Workshop Report  
on  
DISTRIBUTED GENERATION  
INTERCONNECTION RULES

Docket No. 99-DIST-GEN (2)

STAFF REPORT

CALIFORNIA  
ENERGY  
COMMISSION

Figure C.1 Non-islanding inverter test circuit

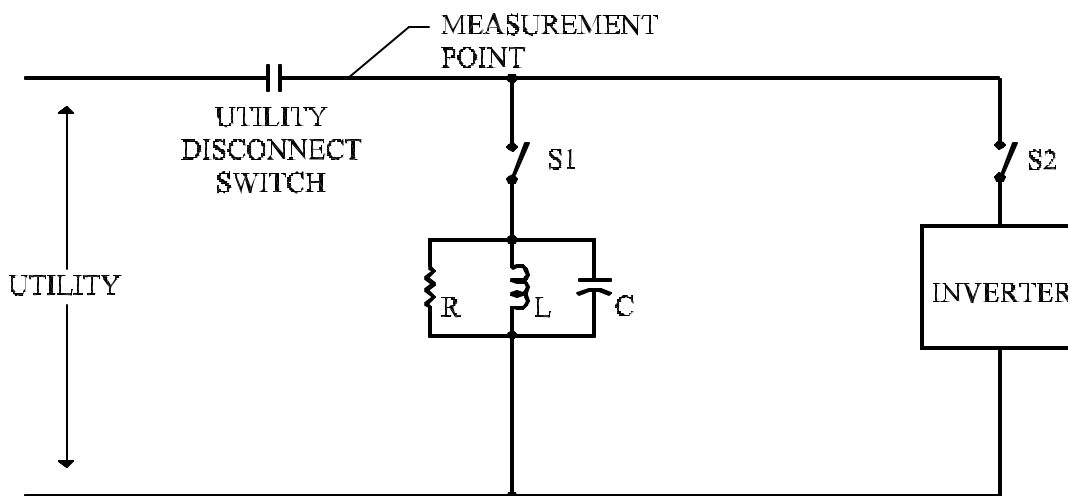
{DR: While verifying your changes we noticed Step 3 needed modifications to reflect that the relay should trip at a minimum P.F of 0.1, 84 or 276 degrees, but at a 10 times higher current pickup level. Also, these tests listed below are for a stand alone relay that have potential and currents inputs and they could be electromechanical or microprocessor based. These tests do not generally apply to an inverter since as far as I know, a reverse power function is not available in its package.} [CMW I know of at least one inverter, the Trace Engineering SW series, that has separate utility and load connections and can be programmed to sell back to the utility or not. The capability of reverse power detection—either through separate outputs like the Trace or by monitoring loads or the PCC—is certainly a plausible feature, one that will likely be implemented if there is economic advantage to do so.]
